Proposed Change 1884

Code Reference(s):	NBC20 Div.B 3.8. (first printing)
Subject:	Accessibility, Visitability and Adaptability of Dwelling Units
Title:	Paths of Travel Within a Visitable Dwelling Unit
Description:	This proposed change requires visitable dwelling units to have a path of travel to all amenities on the entrance floor.
Related Proposed Change(s):	PCF 1882, PCF 1958, PCF 2030, PCF 2031

Figure 1. Example applying the proposed change in minimum width of path of travel in a dwelling unit

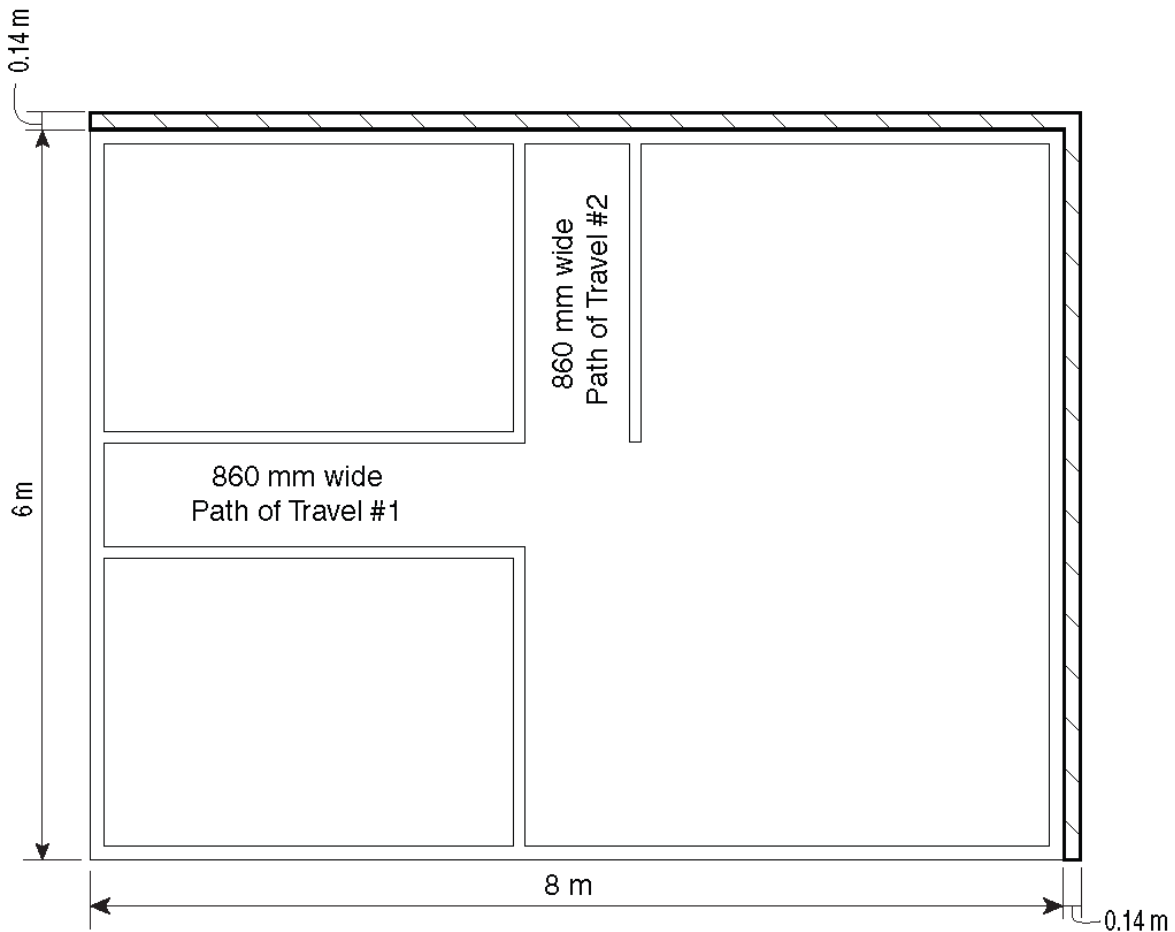
- Unit Length: 8 m
- Unit Width: 6 m
- Orientation of Paths of Travel: 1 corridor width wise and another corridor length wise, so the dwelling unit would need to be increased in its length and its width.
- Change in Minimum Width of Path of Travel: 1 000 mm (PCF 1884) – 860 mm (NBC 2020) = 140 mm = 0.14 m

Table 2 shows the worst-case scenario cost increase if a designer were to simply increase the length and width of a dwelling unit to be compliant with PCF 1884.
